Addendum #1

Attn: Estimator	Date: November 14, 2024
From: Lisa Donahue, Project Administrator	Pages: 58 (including cover page)
Re: Bullock Creek School District 2024 Bond Series 1	Project: 2025 Summer Projects HS/MS/Elem/Pine River/Floyd and Maintenance Building
CC:	Proj. #: A24907

Project: No. 24-120 2023 Bond – Series 1 2025 Improvements

Issue Date: November 14, 2024

NORTH
1/16" = 1'-0"
X01
**DEMOLITION
ROOF PLAN**

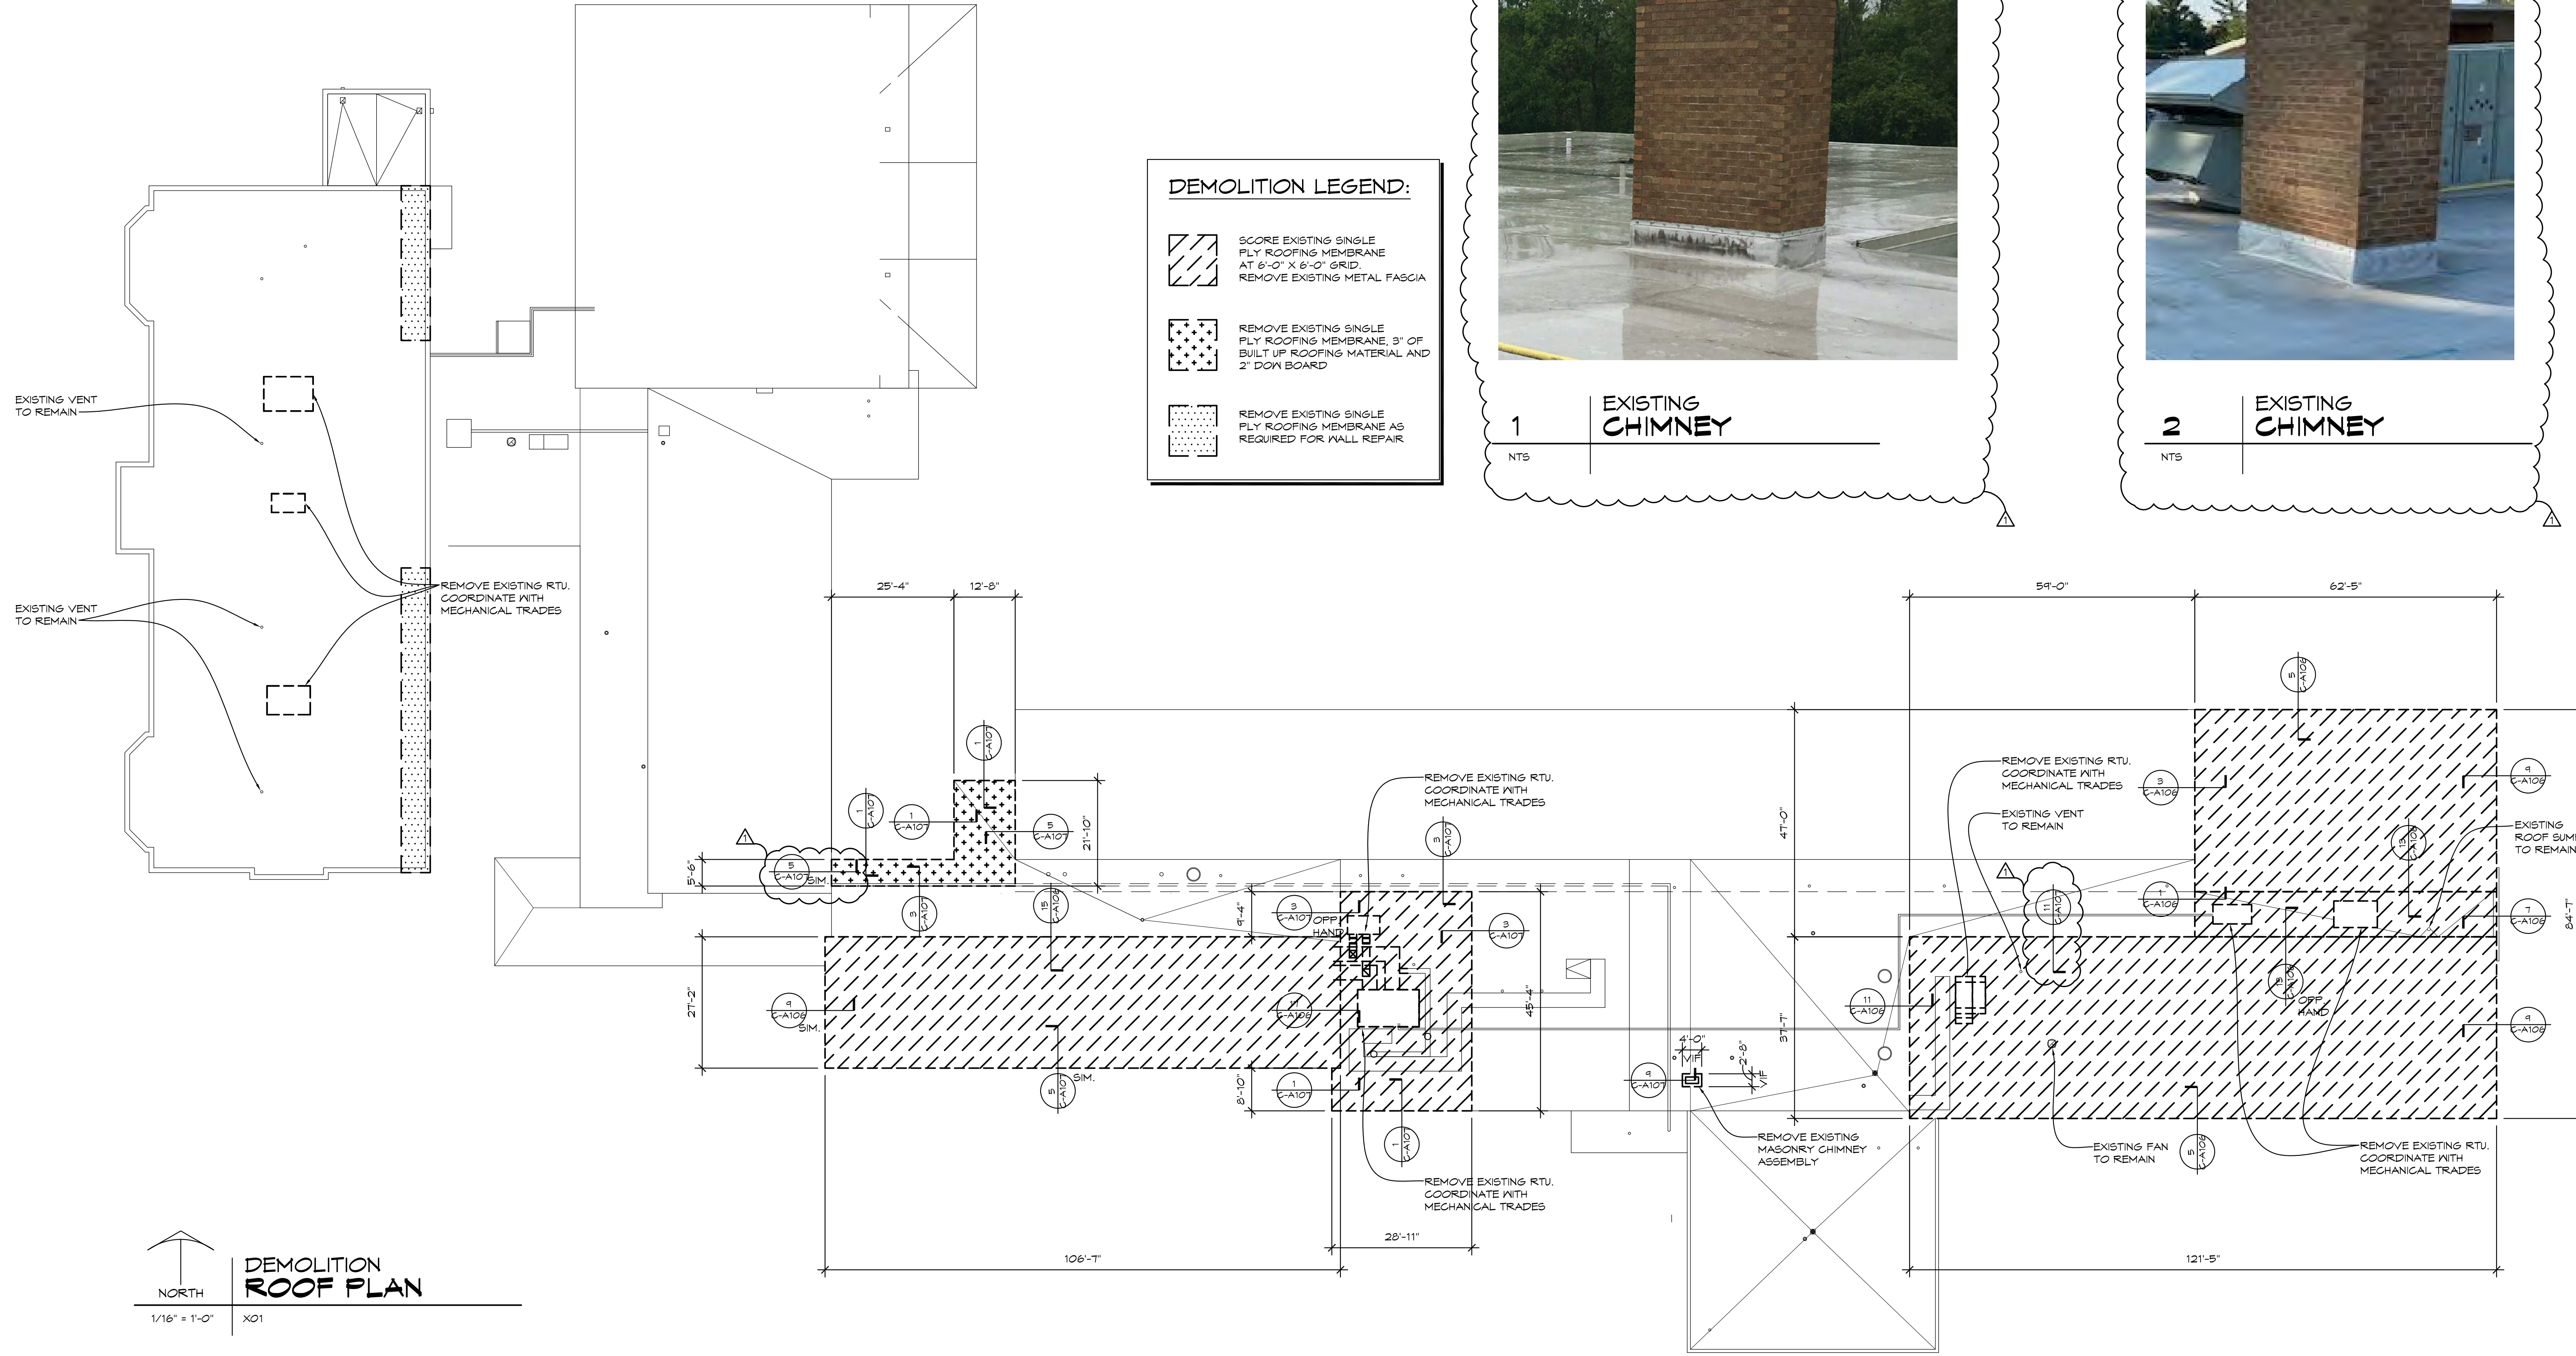
- c. Revised ceiling legend note.
- Item #A5:** Revise Sheet C-A105 as follows:
- a. Plans 1 and 2 revised location of new ductwork penetration.
 - b. Revised roof plan to show repair of roofing at chimney removal.

- c. Updated section tags.
 - d. Revised roofing to call for tapered insulation where new roofing meets existing roofing.
 - e. Raise curb at RTU B1 to provide minimum 8" above new roofing.

- f. Infill roofing insulation where curb for heat recovery unit is removed.
- Item #A6:** Revise Sheet C-A106 as follows:
- a. Details 11 and 12 revised to show existing overhang.

1 DEMOLITION WALL SECTION
3/4" = 1'-0" WSEC01

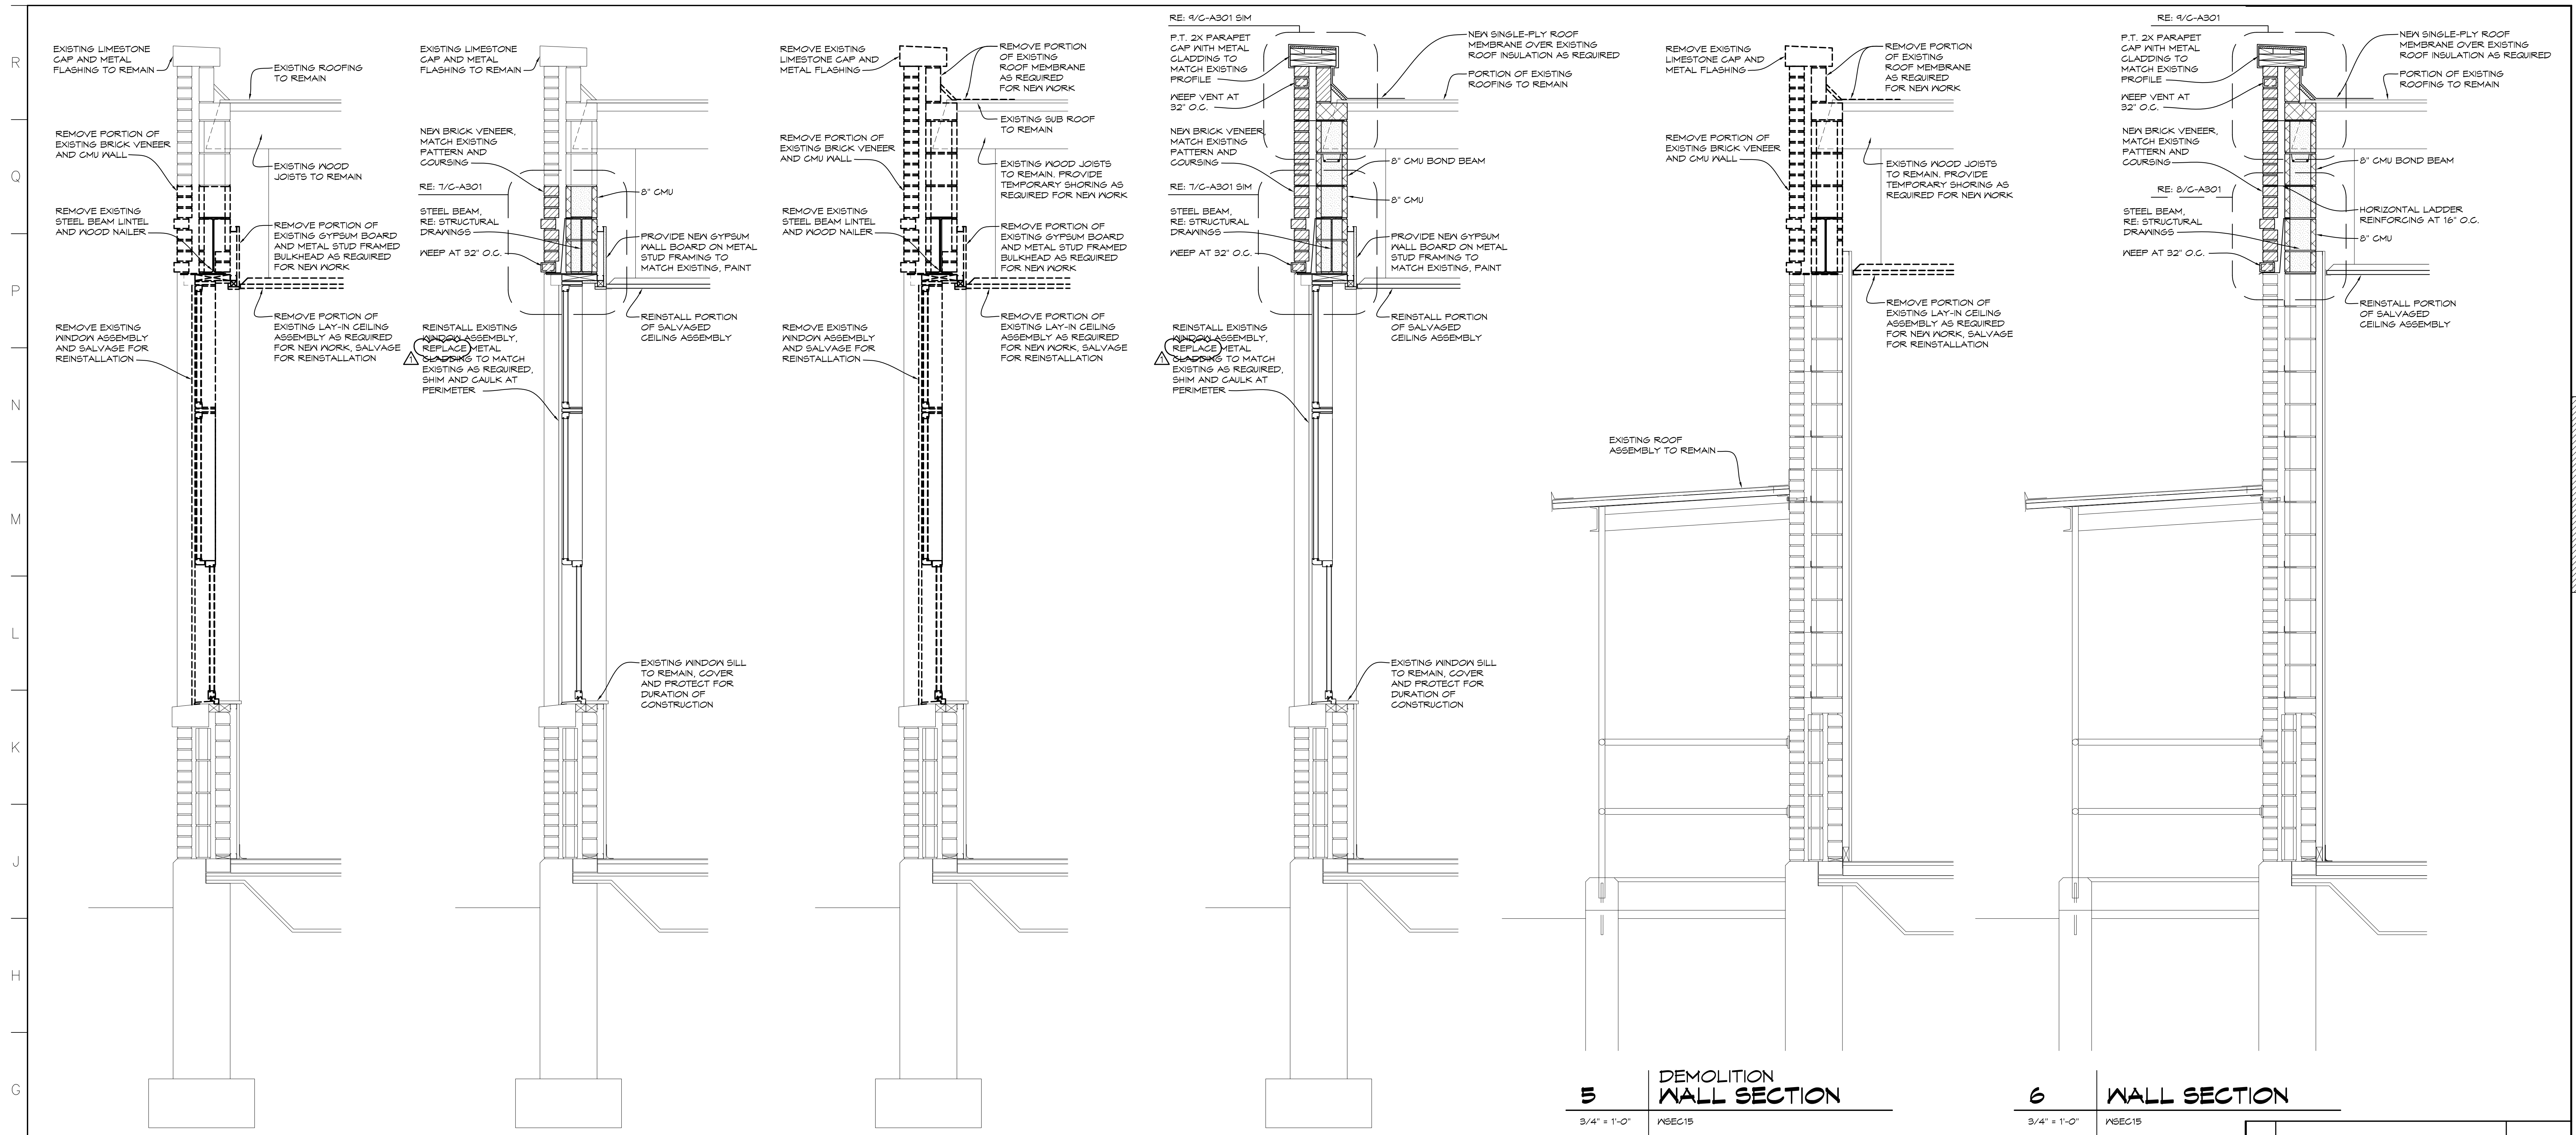
- e. Details 7 and 8 deleted.
- Item #A8:** Revise Sheet C-A201 as follows:
- a. Added replacement of existing break metal cladding at re-installed window assemblies

- b. Added removal of existing overhead wires.
- Item #A9:** Revise Sheet C-A301 as follows:
- a. Details 2, 4, and 7 revised to show new metal cladding at re-installed window assemblies.
